# CCD1: Construction Code Determination Form

# ZRD1/CCD1 Response Form

The subject building is a new proposed 95 story Residential high rise building designed in accordance with the 2008 NYC BC and 2008 NYC Fire Code. Proposed is a cantilever over the neighboring low rise buildings on the same zoning lot.

**RE: 217 WEST 57<sup>TH</sup> STREET RESIDENTIAL TOWER  
FIRE & SMOKE MODELING  
PROJECT NO. 130866.54.000**

Figure 1. Three Views of FDS Model

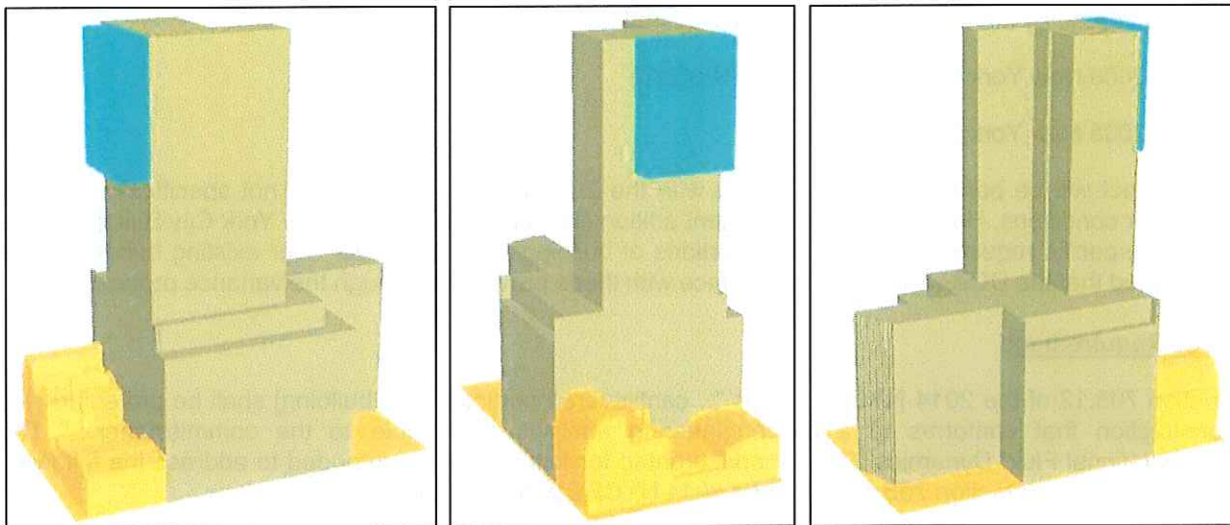
1. The applicant clarifies that in the fire study analysis the fire was applied to the entire roof surface area of the building
2. The applicant clarifies that in the fire study analysis there is no compartmentalization in the existing building.

1. The Fire Engineering Analysis was prepared with the fire applied to the entire roof surface area of the building, and
2. There was no compartmentation in the building.
